FINAL PLAT
IDLE BANKS ADDITION
SEDGWICK COUNTY, KANSAS
2002

RE: SUB 2001-84 -- Final Plat of Idle Banks Addition

RE: SUB 2001-84 -- Final Plat of Idle Banks Addition

CASE NUMBER: SUB 2001-84 -- IDLE BANKS ADDITION**OWNER/APPLICANT:** Delbert I. and Elizabeth A. Wilson, 8942 N. Oliver, Wichita, KS 67147; Brian L. and Kristen C. Shelton, 127 N. Colby, Valley Center, 67147; Harvey E. And Bonnie J. Siemens, 7820 SW Huntoon, Topeka, KS 66615; James and Zelda Brownlee, 1930 W. Evanston, Valley Center, KS 67204;**SURVEYOR/ENGINEER:** Reiss and Goodness Engineers, Attn: Robert Previtera, 2160 W. 21st St., Wichita, KS 67203**LOCATION:** North of 85th St. North, East side of Oliver St.**SITE SIZE:** 60.88 Acres**NUMBER OF LOTS**

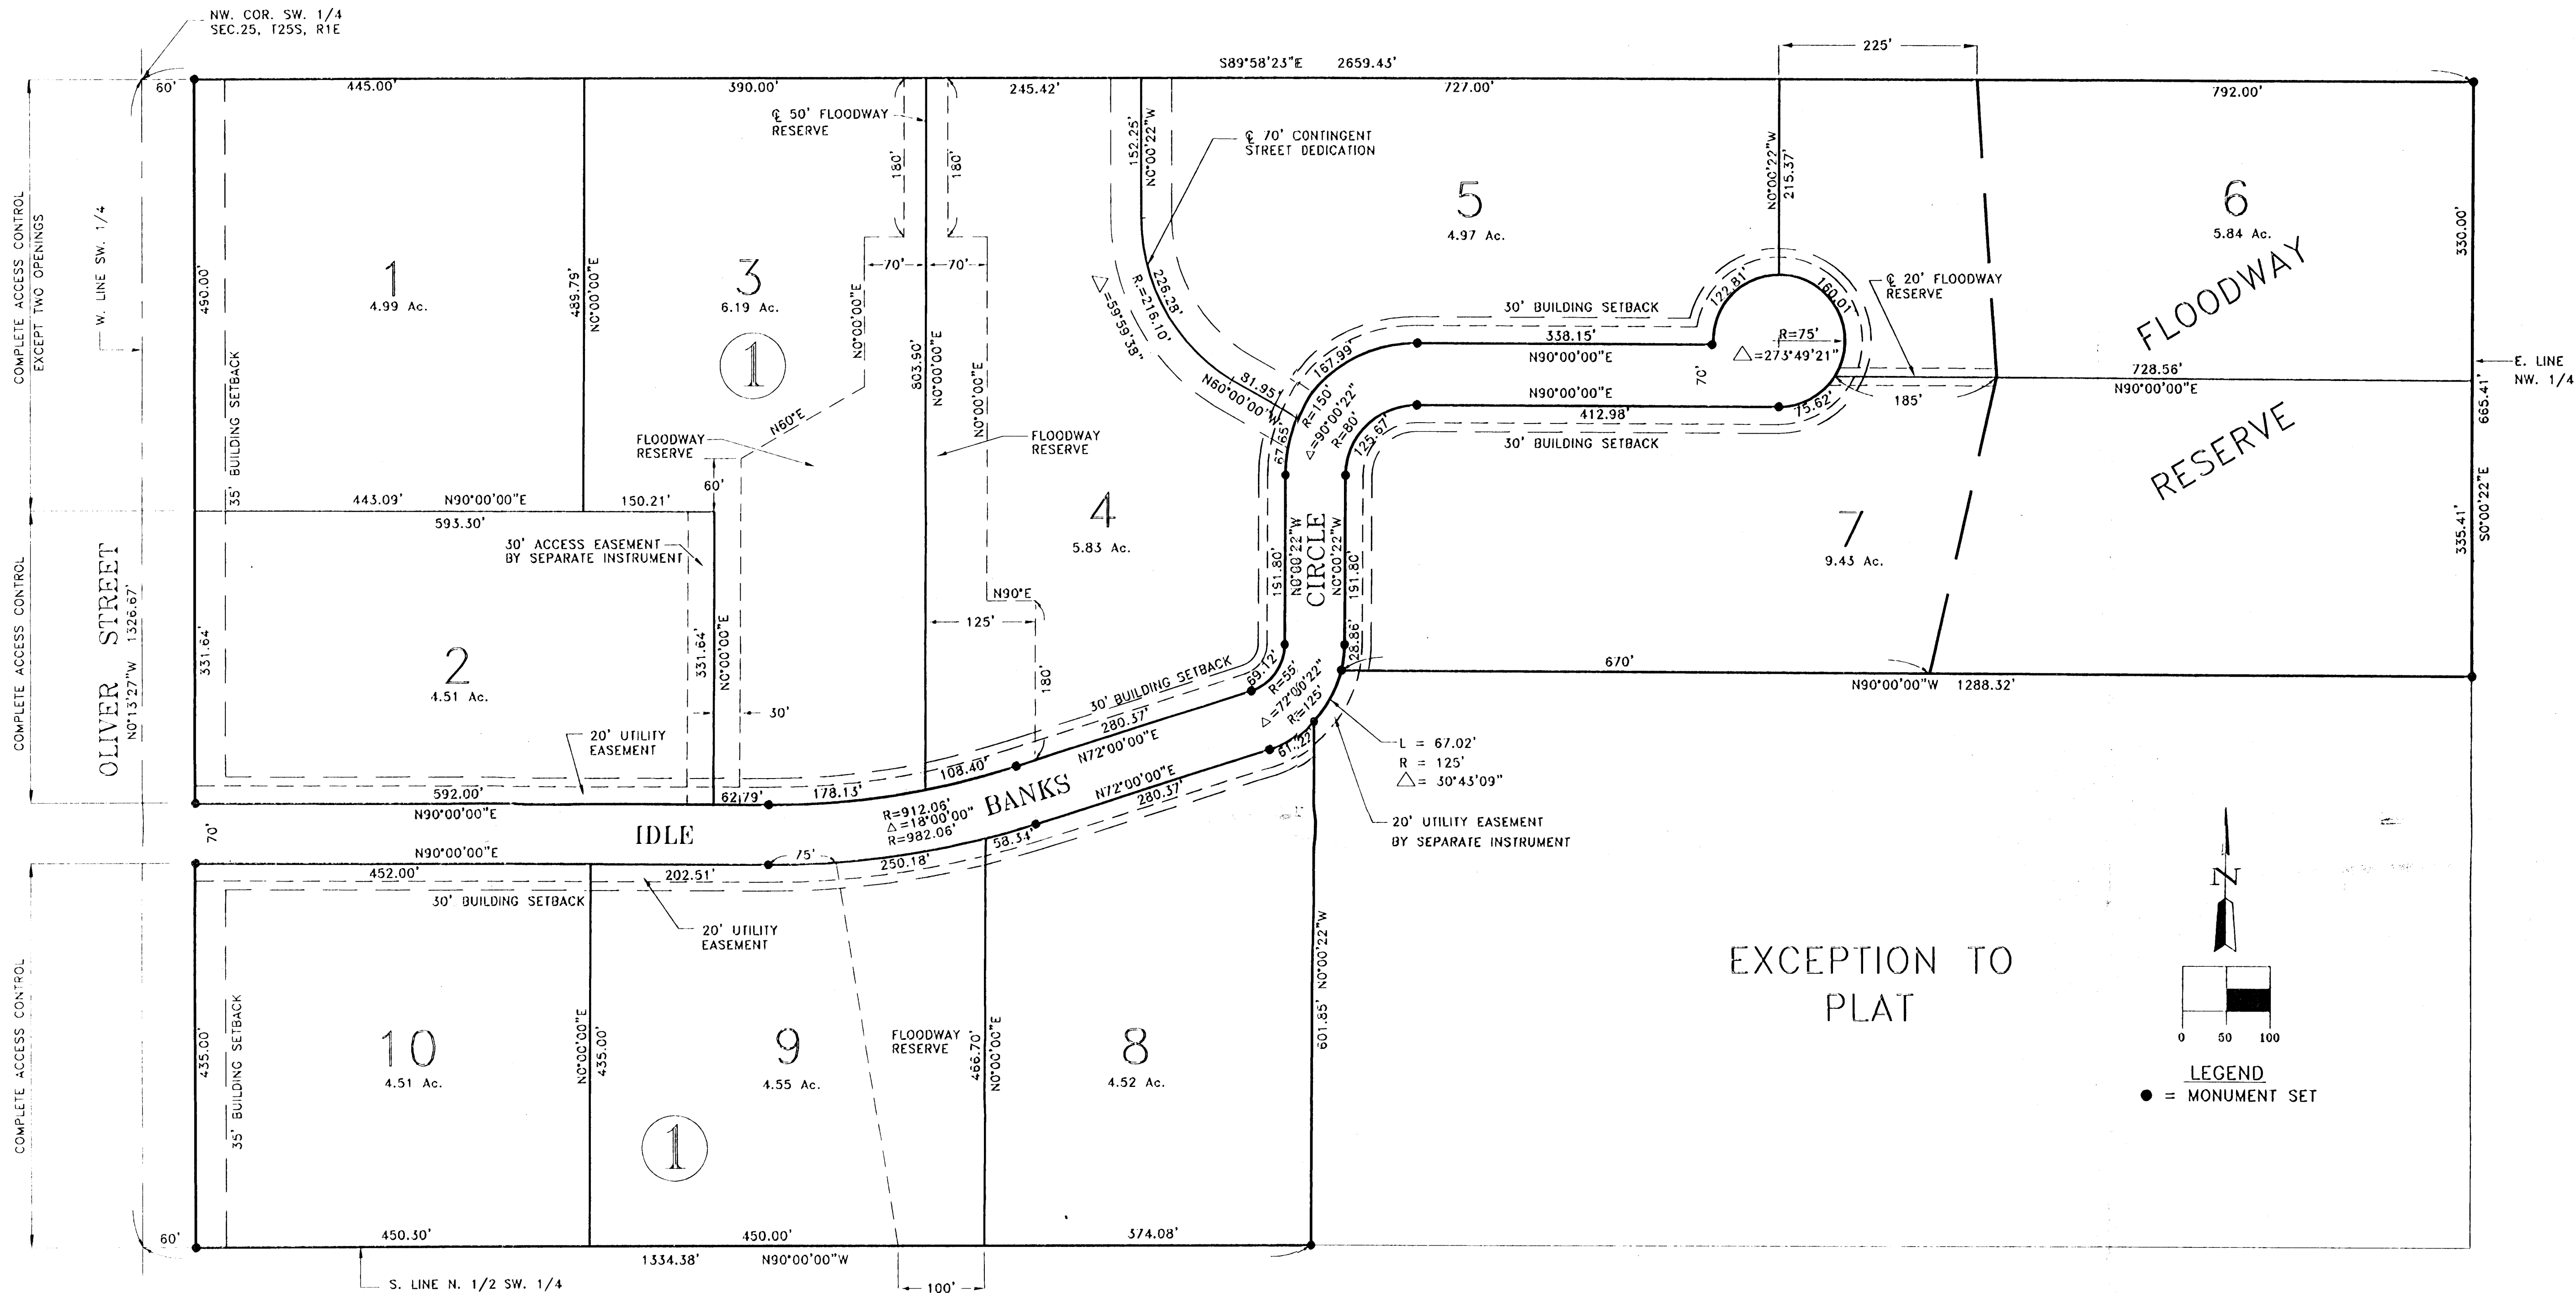
- A. Since neither municipal water nor sanitary sewer is available to serve this property, the applicant shall contact the Environmental Health Division of the Health Department to find out what tests may be necessary and what standards are to be met for approval of on-site sewerage facilities and water wells. A memorandum shall be obtained specifying approval. A layout denoting additional floodway reserve is needed for Lot 6 to determine buildable area. Soil testing is required.

- D. County Engineering needs to comment on the status of the applicant's drainage plan. County Engineering has advised that a HEC-2 computer run is required across Lots 6 and 7, and additional floodway reserve will be needed on Lot 6 as determined by the computer run. Minimum pads will need to be determined by the computer run. The drainage easements between Lots 3 & 4, between Lots 6 and 7, and between Lots 8 & 9, Block 1, need to be changed to Floodway reserves. A Master Lot grading plan is needed.

- H. The Applicant is advised that in regard to the structure on Lot 1 within the required 35-ft building setback, that while such areas of the existing structure may be retained, no enlargement of the building in such area will be permitted and if removed, all subsequent rebuilding shall observe building setbacks.

- I. Approval of this plat will require a waiver of the lot depth to width ratio of the Subdivision Regulations for Lot 3 and Lot 6. The Subdivision Regulations state that the maximum depth of all residential lots shall not exceed 2.5 times the width. *A modification has been approved by the Subdivision Committee.*

- M. **County Surveying** has advised that the legal description needs to be corrected. "Section 25 South" needs to be revised to "Section 25, Township 25 South". The curve needs to be noted on the right or southeast side of the chord.

- N. The plat's text shall include language that a drainage plan has been developed for the plat and that all drainage easements, rights-of-way, or reserves shall remain at established grades or as modified with the approval of the applicable City or County Engineer, and unobstructed to allow for the conveyance of stormwater.
